THE HIGHLAND COUNCIL

PLANNING APPLICATIONS COMMITTEE – 11 November 2014

14/02735/FUL: MeyGen Ltd Ness Of Huna And Ness Of Quoys

Supplementary Report No 1 Report by Area Planning Manager

PCUB Elevations Phase 1a & 1b

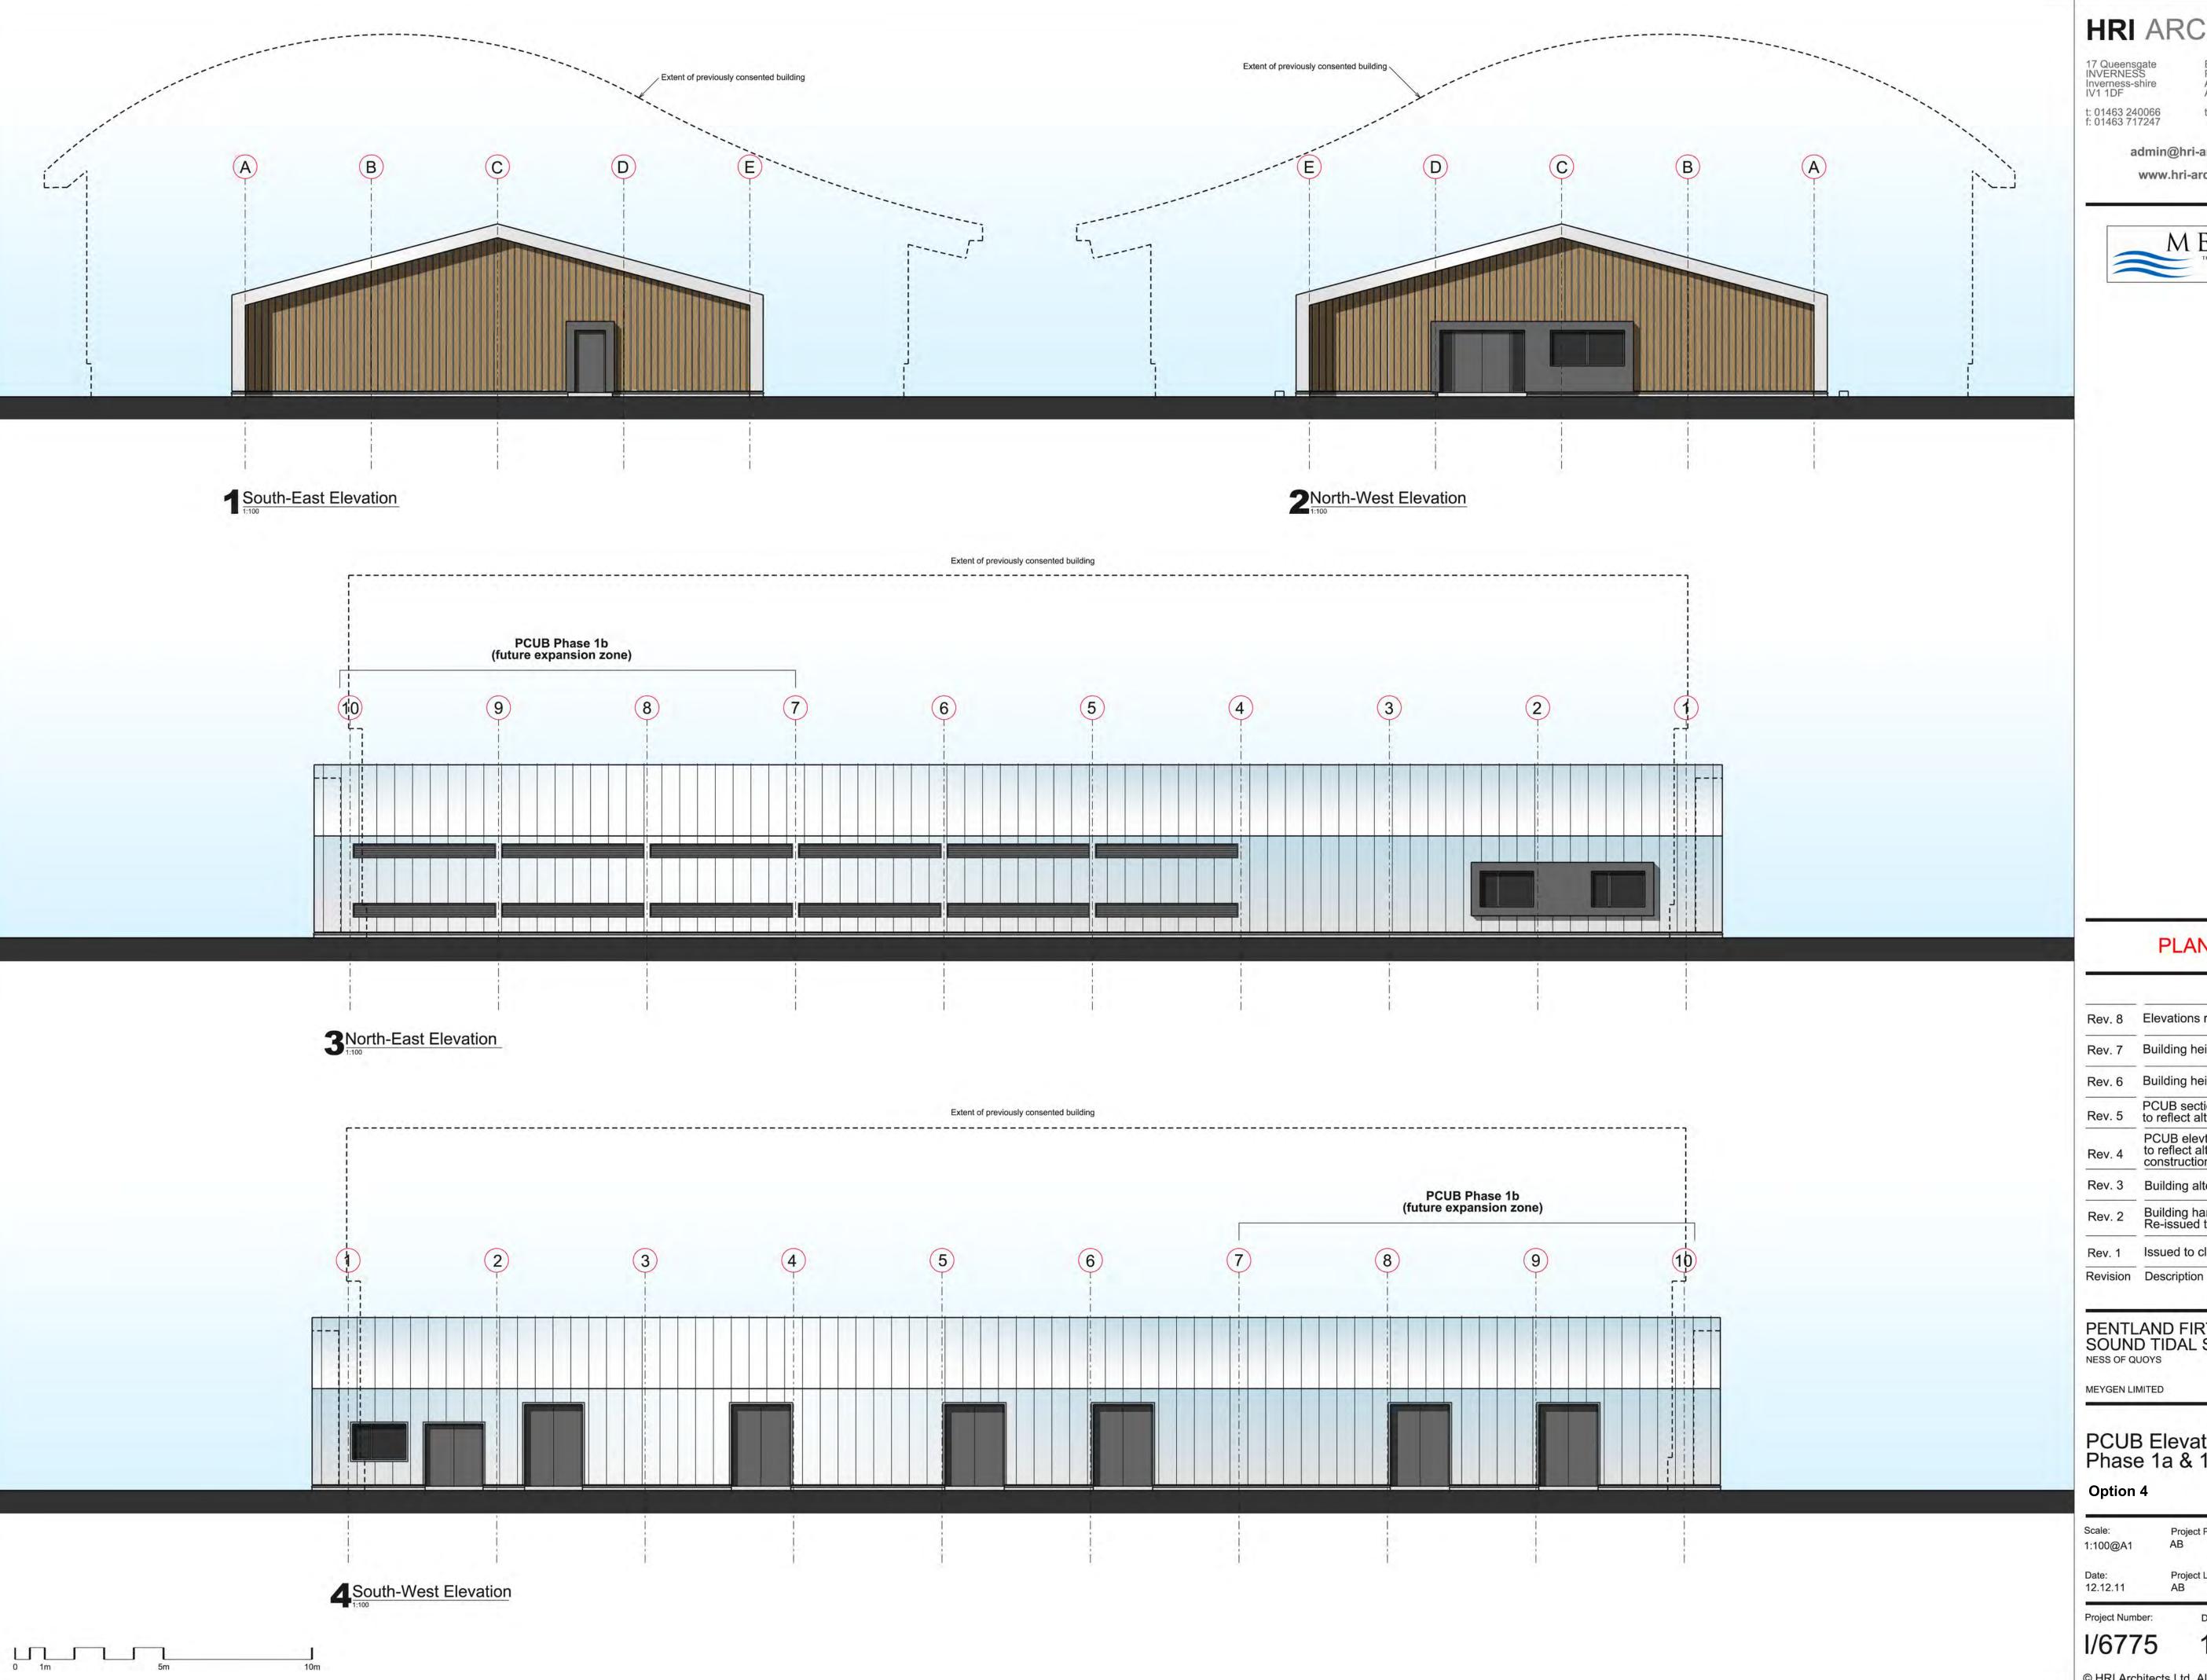
- 2.3 The external appearance of the buildings has been amended. The amendments now proposed (as outlined in section 1 above) represent an improvement to the proposal. Although the design of the buildings remains unaltered in that they are rectangular buildings with dual pitched roofs, the aluminium and timber finishes and detailing proposed are high quality, more reflective of the function of the buildings and reducing the resemblance to standard large agricultural sheds. The enhanced detailing helps break up the mass of the building and helps lessen the appearance of its scale. This was a key concern raised in relation to the original proposal for amended design.

- 2.4 The potential for the overall design of the buildings to remain as previously approved under 12/02874/FUL but at a reduced scale was discussed with the applicant. The reasons provided, as summarised in section 1.4 above, are accepted in that the curved roofs would be out of proportion given the dimensions of the significantly reduced scale buildings now proposed. It is also recognised that the applicant does not wish the design buildings to attract visiting members of the public for health and safety reasons related to their function.

- 2.5 It is considered that the scale, massing and external appearance of the buildings can be absorbed into this landscape setting without significant landscape or visual impact, this is demonstrated in the photomontages that the applicant has submitted in support of the amended proposal. The amended external appearance gives the impression of a high quality development in the landscape.

- 1.2 In response to this, the applicant has amended the external appearance/finish of the buildings. External walls and roofs will be aluminium standing seam cladding, incorporating local masonry elements, and gables will be vertically timber lined over a black anodised carrier board. It is not proposed to change the design, dimensions, footprint or siting of the buildings from that presented to Committee in September.

- The gables emphases the extruded concept; the sectional form projects 1000mm beyond the gable line and the returns soffits are timber lined. The gable is similarly vertically timber lined over a black anodised carrier board. The gable details will help break up the form of the building from views east and west (Canisbay Kirk) along the A836.
